Technical Service Bulletin: tsb100821

Enlarge Head Gaskets

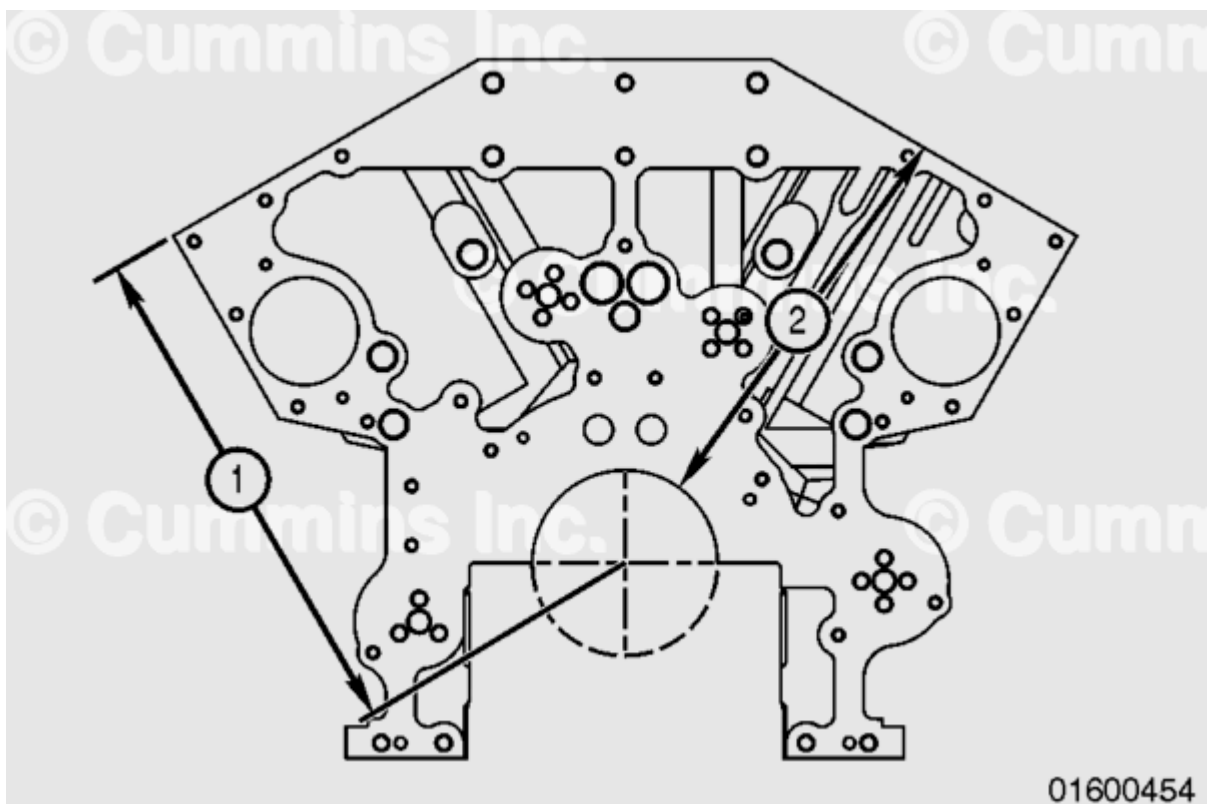
This document announces the availability of enlarge head gaskets for QSK45 and QSK60 engines. To maintain proper engine operation, enlarge head gaskets are needed for blocks which have the top surface or deck machined during overhaul.

The following dimensions **must** be measured to determine the correct enlarge head gasket to be used:

- Block deck to crankshaft centerline (1)
- Block deck to crankshaft bore (2).

Block Deck Height from Crankshaft Centerline (1) for Oversize Head Gaskets			
	mm		in
For +0.25 mm [0.010 inch] oversize gasket	529.275	MIN	20.8376
	529.425	MAX	20.8435
For +0.50 mm [0.020 inch] oversize gasket	529.025	MIN	20.8278
	529.175	MAX	20.8337
For +0.76 mm [0.030 inch] oversize gasket	528.765	MIN	20.8175
	528.915	MAX	20.8234

Block Deck Height from Crankshaft Bore (2) Oversize Head Gaskets			
	mm		in
For +0.25 mm [0.010 inch] oversize gasket	432.812	MIN	17.0398
	432.962	MAX	17.0457
For +0.50 mm [0.020 inch] oversize gasket	432.562	MIN	17.0300
	432.712	MAX	17.0359
For +0.76 mm [0.030 inch] oversize gasket	432.302	MIN	17.0198
	432.452	MAX	17.0257
